STAFF REPORT

PLANNING & ZONING COMMISSION

Wednesday, December 13, 2017
7:00 P.M.

1
A2.1
EXTERIOR ELEVATION - SOUTH
1/4" = 1'-0"

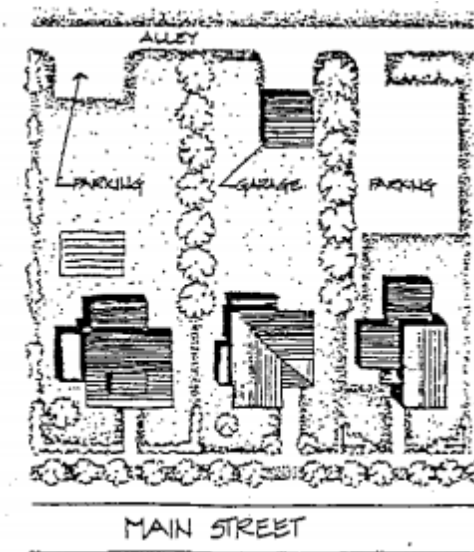
- The proposed project is in line with site considerations of the PAG.
 - Access to rear yard parking lots and storage or garage buildings should be from alleys whenever possible.
 - The proposal has designed their parking lot in this fashion.
 - Commercial lots should be paved with asphalt, brick, concrete, or tar and chips as required in the Powell Zoning Code.
 - Renderings show an asphalt type of pavement.

RIBBON WINDOW

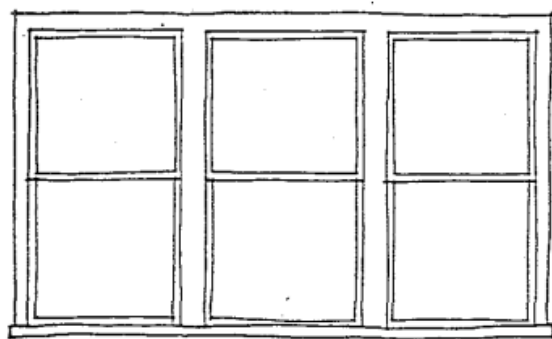
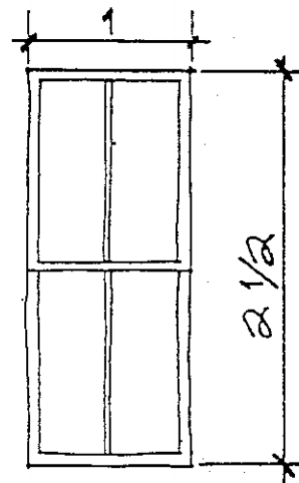
- The proposed project is somewhat in line with the PAG.
 - The front elevation of the proposal displays the Ribbon style, one of the three historically correct window styles with a 2-over-2 pattern. (Page 48)
 - Further examination by the Powell Architectural Advisor and HDAC is needed to determine whether the panels above the front windows are appropriate.

Townhome portion of commercial building.

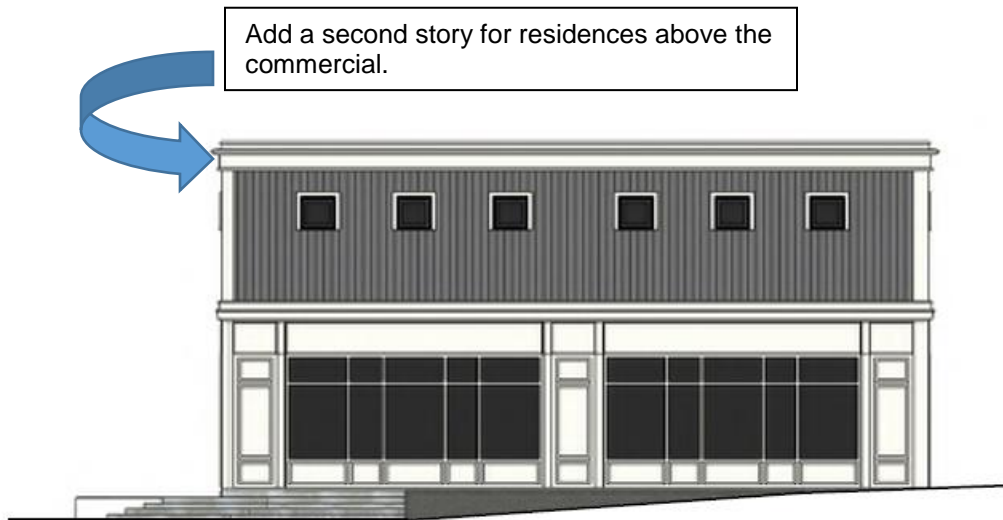
In the image below, we show an option for adding townhome portions to a commercial building. In this manner, there is still prominent commercial facing Grace Drive, and can be intermixed with a mix of townhomes and possibly upstairs apartments. Does this increase costs? Probably yes. Does this increase rents to make up for costs, probably yes. Will it take longer to rent the commercial space rather than the apartments, probably yes.

BUILDING 1: 27 TOTAL SPACES

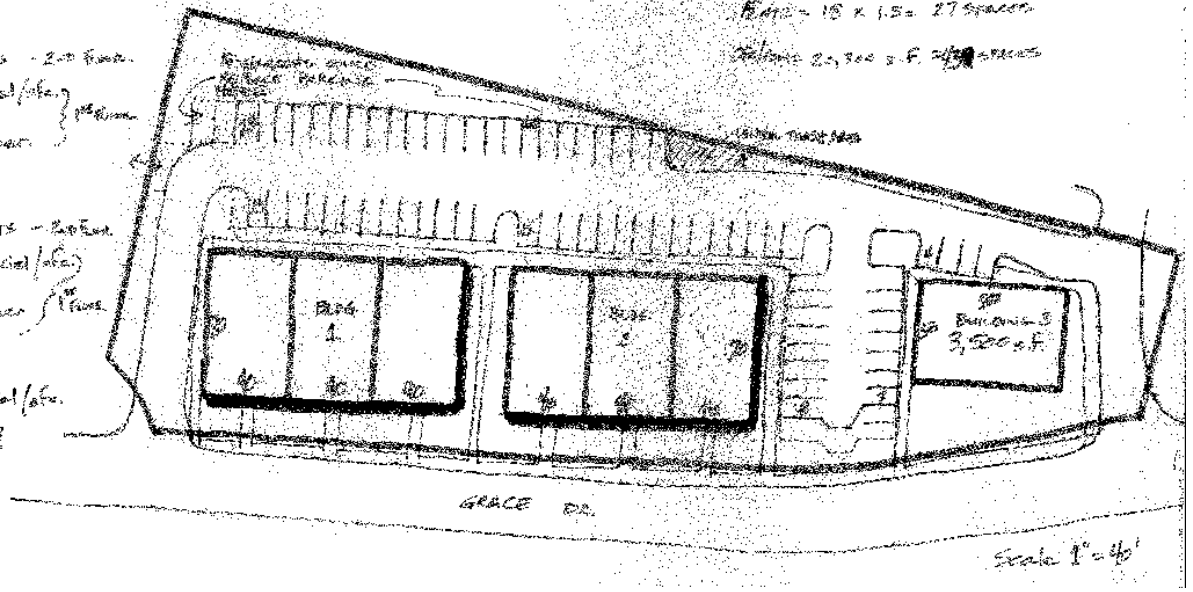
- 4) The residential density of the proposal should stay in line with the Downtown Business District. Staff would recommend between 18-21 units if the existing drive access is upgraded to a public street and other changes to the site plan and mix are made.
- 5) Submit traffic analysis of proposed one way site operation and need for turn lane on the access road.
- 6) A market analysis and comparison between what the applicant is proposing and what Staff is recommending should be done in order to help with the Commission decision making. A comparison of a more of a mixed use development than what is proposed to be primarily residential is important to see. Staff put together a different proposal for having more of a mixed use, 1st floor commercial/retail/office service oriented businesses and 2nd floor flats as what we feel is a viable option:

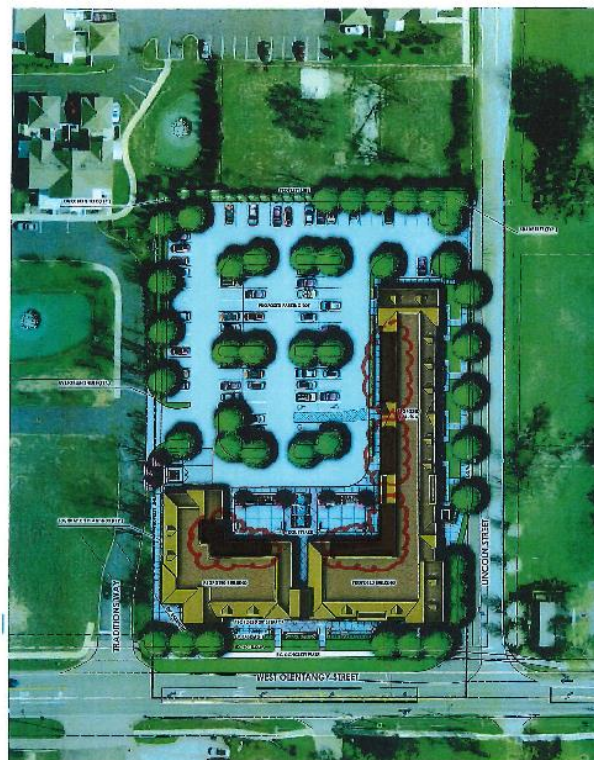
To remove the rear portion of the roof design and extend the walls higher in its place to create more of a parapet design. The following color site plan shows the extent of what is being removed (blacked out in photo):

Staff feels that as currently proposed, this is a minor design change, does save some cost to the owner, and has little effect on the overall quality of look. If this saves some rents for future tenants and it allows for quicker rental of the units, Staff is supportive of this request.
